Development at Roundstone Farm, Angmering

A/168/21/PL Erection of 76 No. dwellings, means of access, public open space, play areas, associated infrastructure & landscaping. Land South Of Littlehampton Road and East of Worthing Road Angmering BN12 6PN

Objection to A/168/21/PL

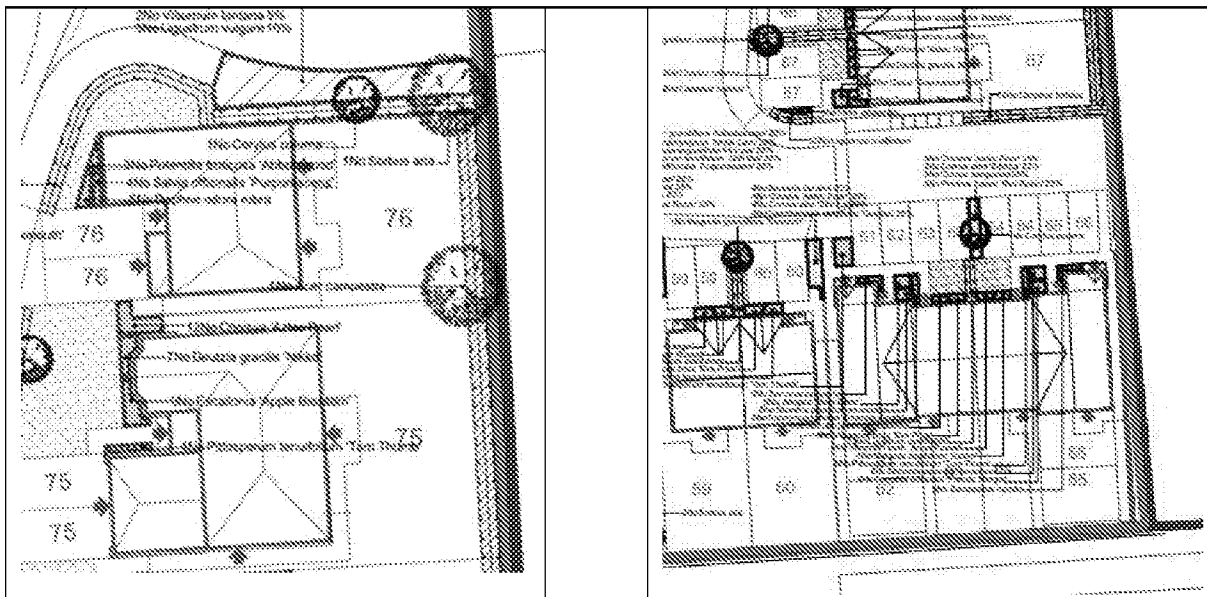
The gap at this point is only 712 metres wide, and the application site would reduce this by about 200 metres or 28%. In addition, the breaching of Policy SD SP3 is likely to set a precedent which would result in further incursions elsewhere in the gap and/or to the immediate east of the current site. This probability is heightened by the proposed layout of the development which clearly facilitates future development in the remainder of the field to the east. This would effectively subsume Roundstone Farm into East Preston, reducing the settlement gap to only 230 metres.

The Landscape and Visual Impact Assessment considers that users of the footway / cycleway past the site entrance and drivers on the A259 “will have views into the site and are likely to experience the most noticeable visual change”. This will adversely affect their perception of the gap between the two settlement areas and the separate identity of the villages.
